SPLIT RAIL WINERY

DESIGN REVIEW SUBMITTAL

Re: DSRFY2020-19 – 3200 W. Chinden Blvd.

Re: DSRFY2020-19
3200 W. Chinden Blvd. – Split Rail Winery

LANDSCAPE PLAN 1" = 20'-0"

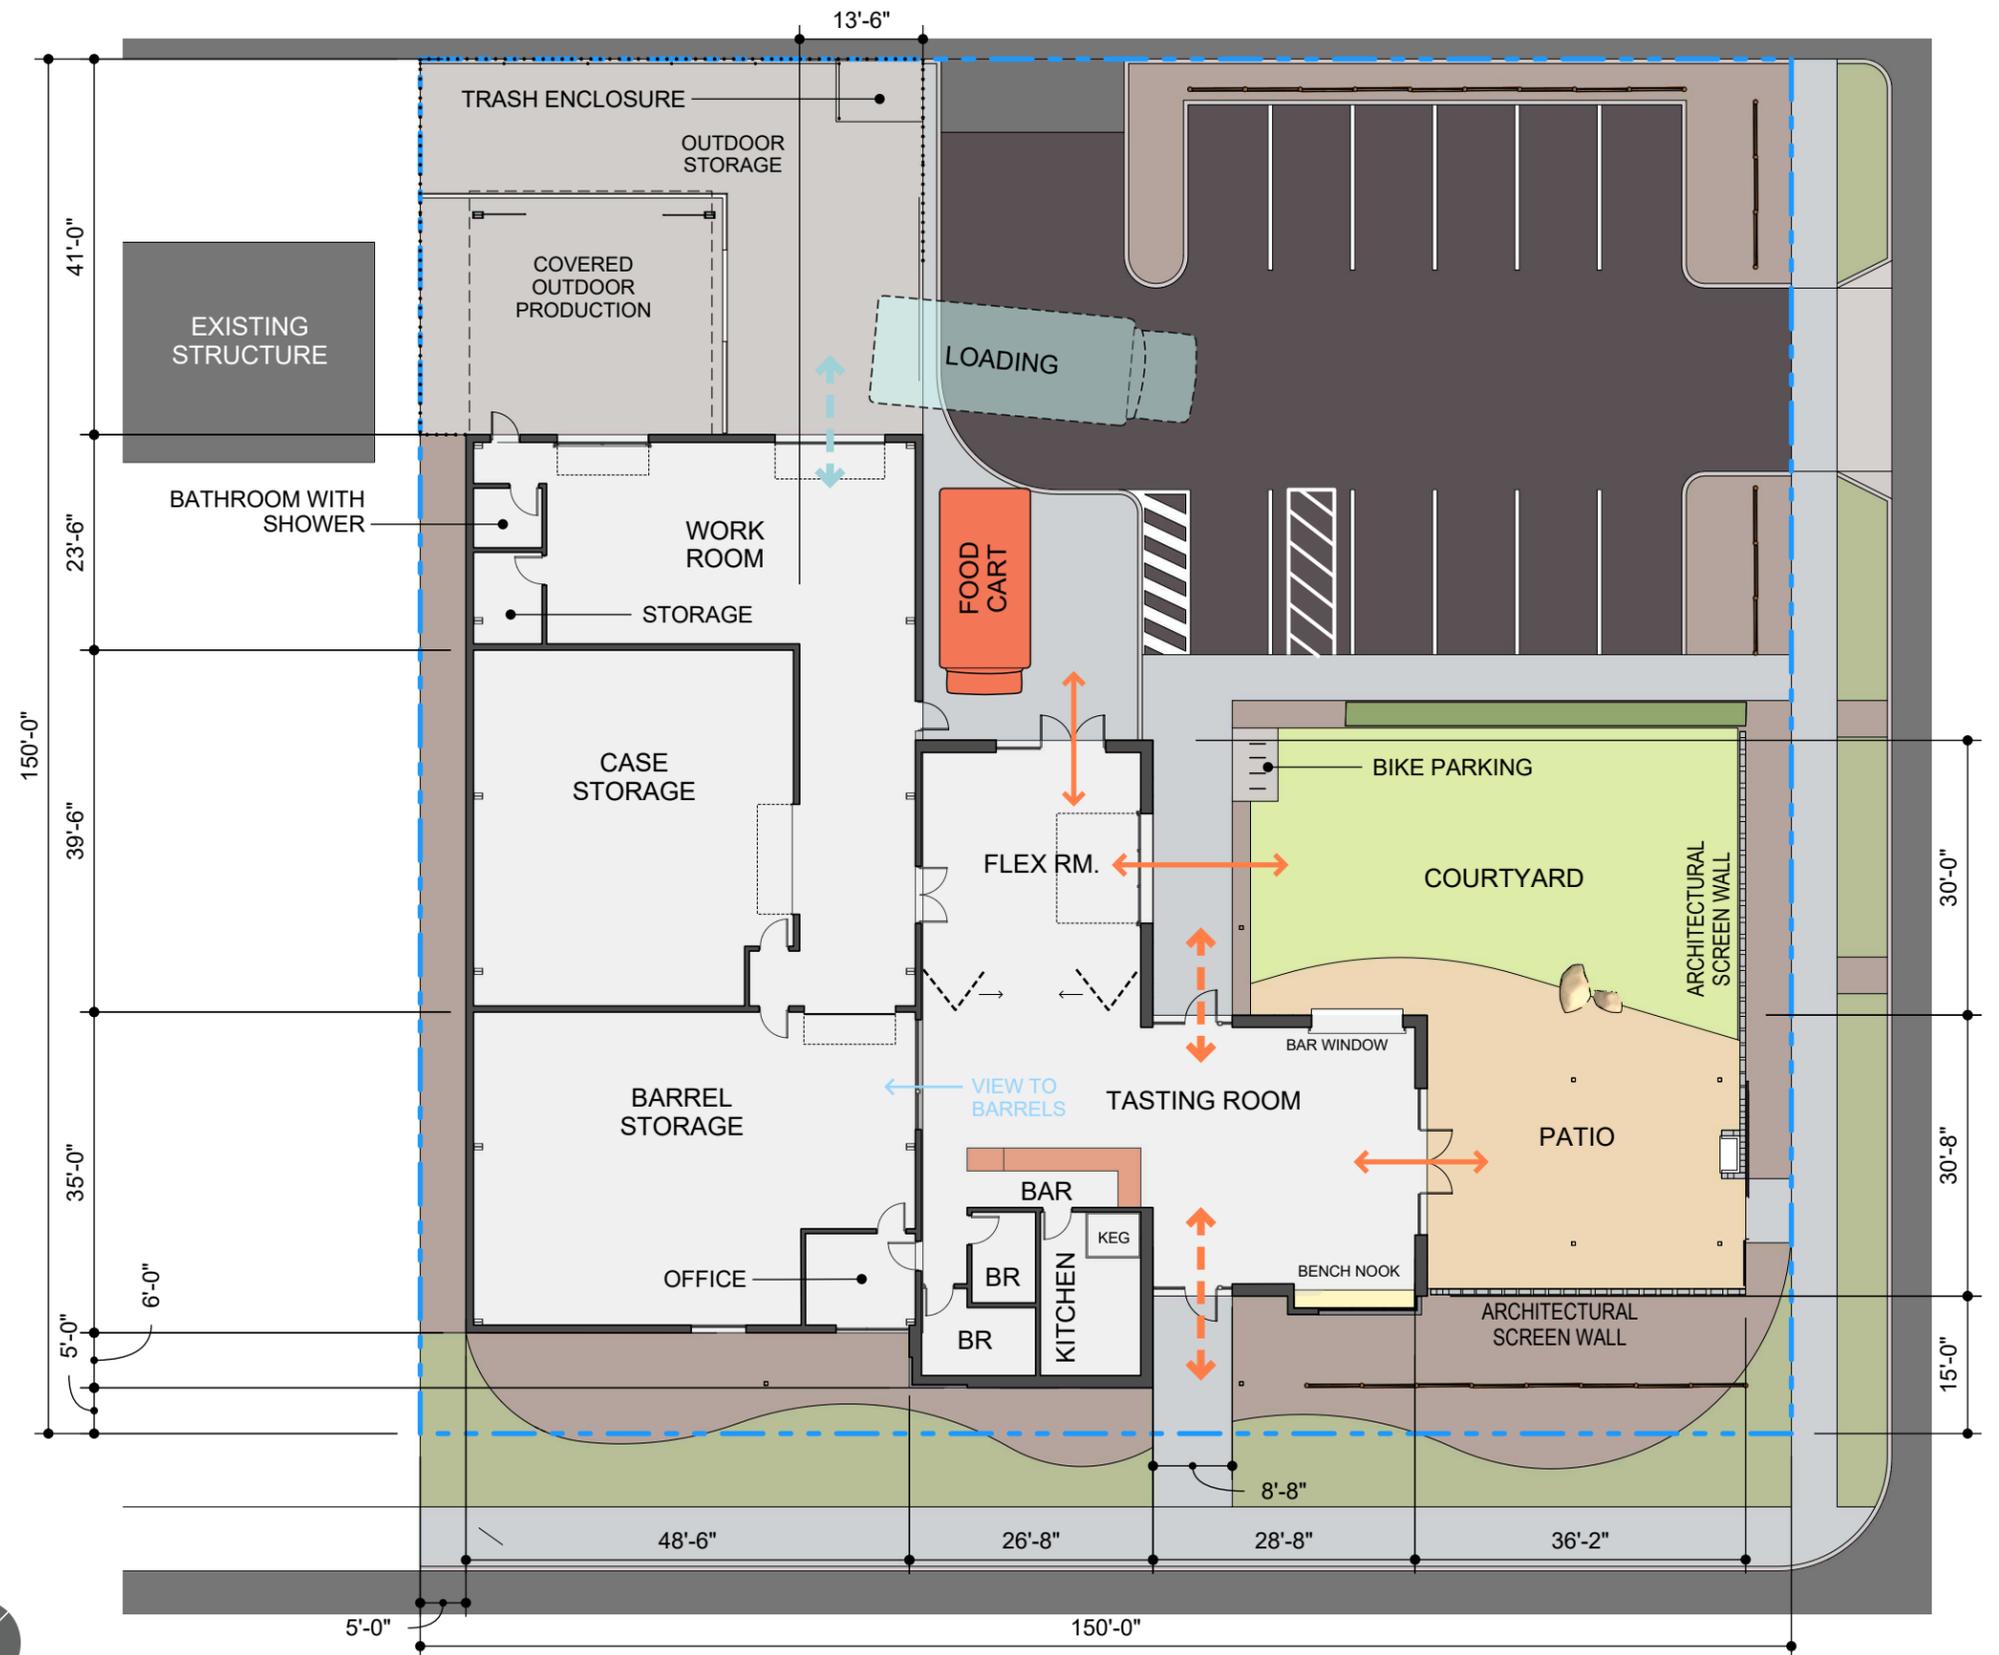
16	8-4G Sustainable Development Provisions	<p>All new developments shall be required to provide for sustainable development practices based on a point system as follows:</p> <p>Five thousand one (5,001) to fifteen thousand (15,000) square feet: eighteen (18) points. Not enough information provided to determine if project is compliant.</p>	Based off square footage requirements, 18 sustainability points are being proposed. Please refer to "DSRFY2020-19_Sustainability Check List" document included with submission.
17	8-4I-3 General Landscaping Standards and Irrigation Provisions	Must increase number of species of class II or III trees by 1 due to the number of trees totaling 13.	Please refer to revised landscape plan.
18	8-4I-4 Landscaping Provisions for Specific Uses	A minimum of one class III or class II tree shall be planted in the frontage and every adjacent street side. An additional class I tree shall be planted in the corresponding setback for every	Please refer to revised landscape plan.

ELEVATIONS 1/16" = 1'-0"

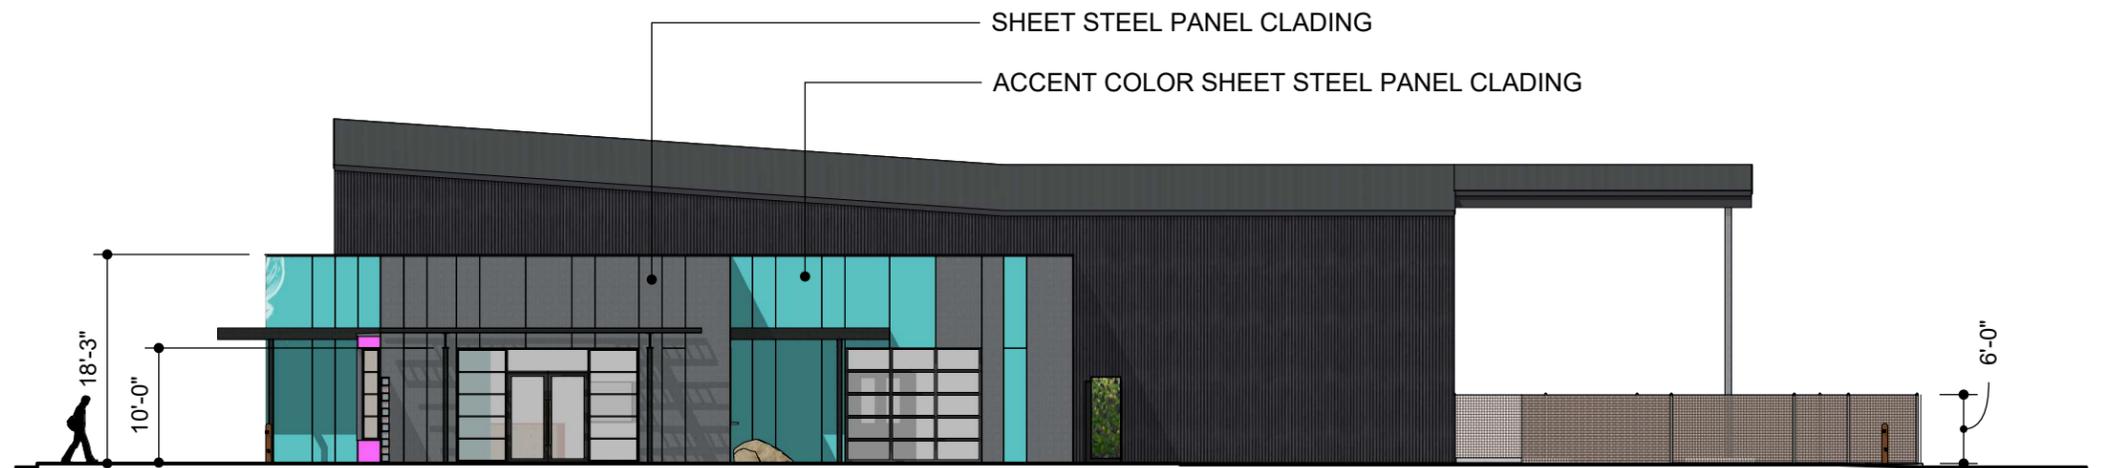
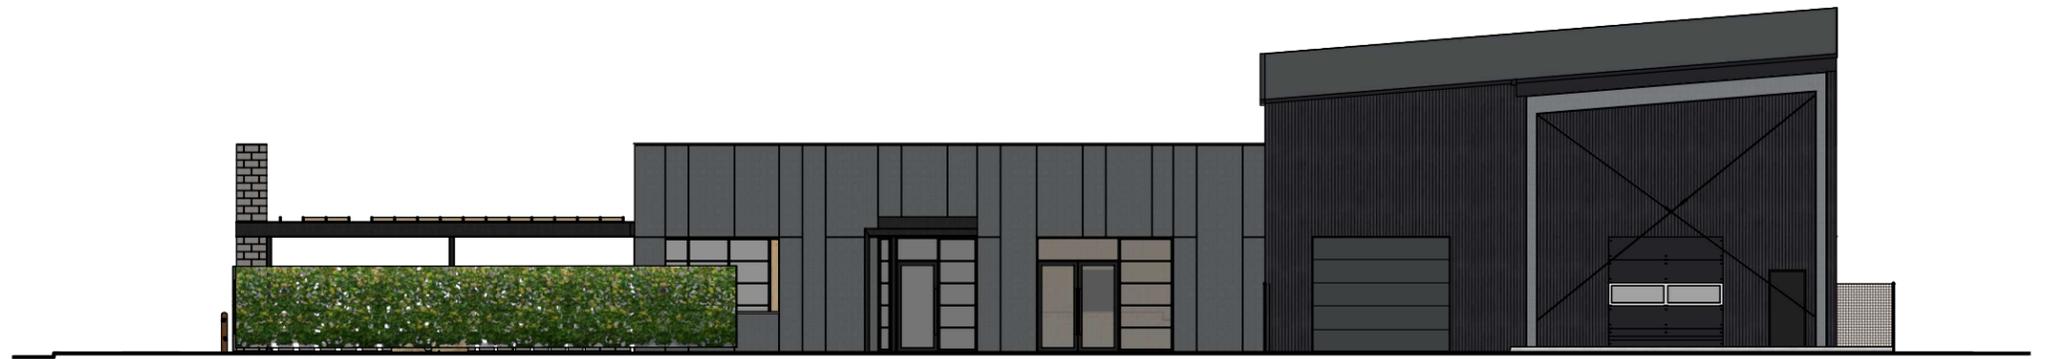
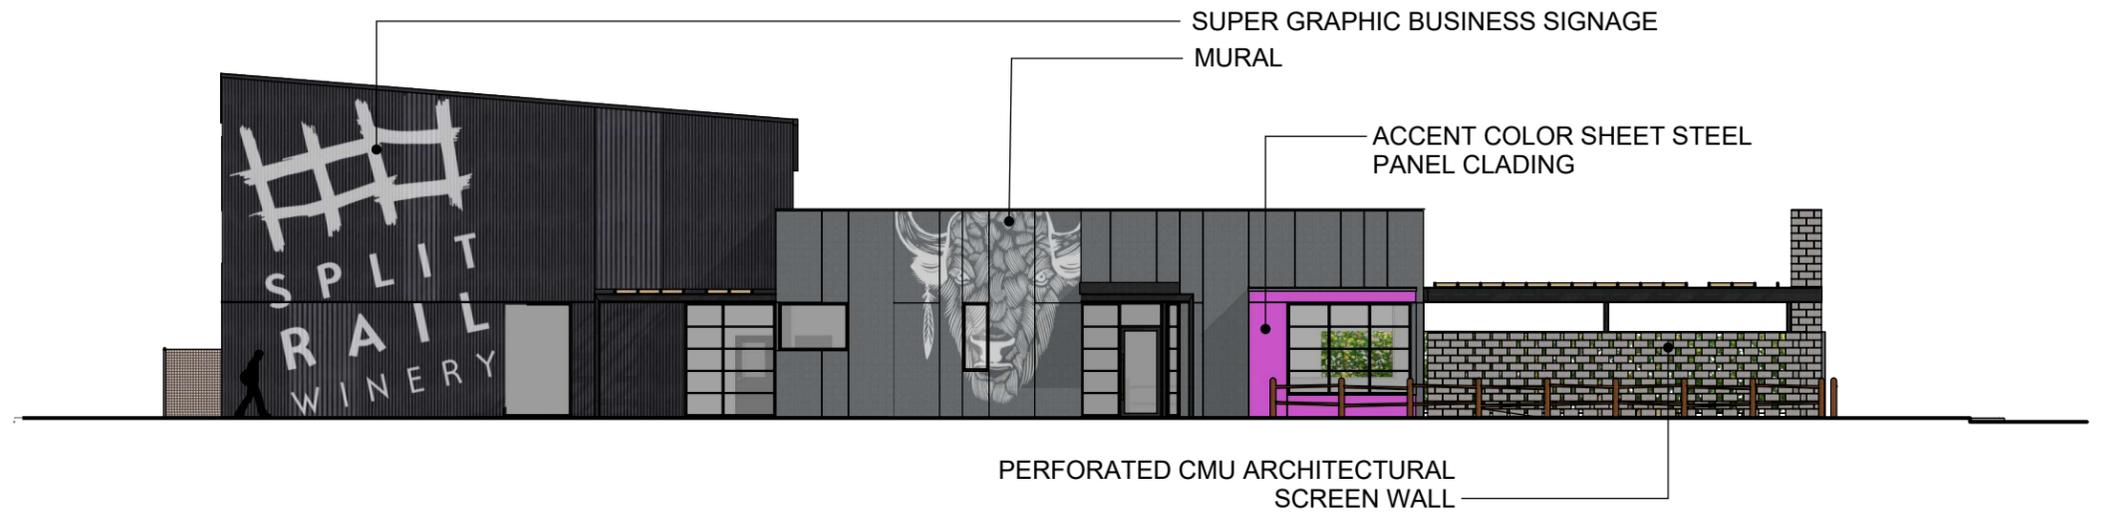
21		<p>Long roofline on west side needs to be articulated.</p> <p>“Rooflines exceeding fifty feet (50'), should incorporate relief to the perceived building mass by providing roofline variation. Roofline variation should be achieved using one or more of the following methods: a) vertical offset in ridgeline; b) horizontal offset in ridgeline; c) variations in roof pitch; d) gables; and e) dormers.” (8-4C-4)</p>	The western ridge line of the shed roof has been offset vertically towards the back of the building to meet requirements of 8-4C-4.

22		Fenestration on west side needs to be addressed.	<p>Future development of the neighboring site to within 5' of the property line would render windows ineffective. Also, windows at this elevation would be limited by code due to the 5' separation distance of the adjacent property line.</p> <p>Additionally, glazing into cooled and conditioned wine storage space is not desired particularly at the west facing façade.</p>
23		Fencing along Chinden and 32nd wall is not a strong pedestrian component. Treatment such as openings, visual connection, or artwork to strengthen pedestrian relationship to the street are suggested.	Spaced openings in the architectural screen wall provide glimpses into the patio space. A retractable steel gate on the corner of 32 nd and Chinden provides pedestrian access.
24		Note staff report where not enough information or noncompliance.	Noted.
25		Staff will send perimeter landscaping and screening ordinance to applicant to ensure Osage is compliant	Design does not fall under the applicability of Perimeter Landscaping Provisions 8-41-5 (B) provided by staff and is therefore compliant.
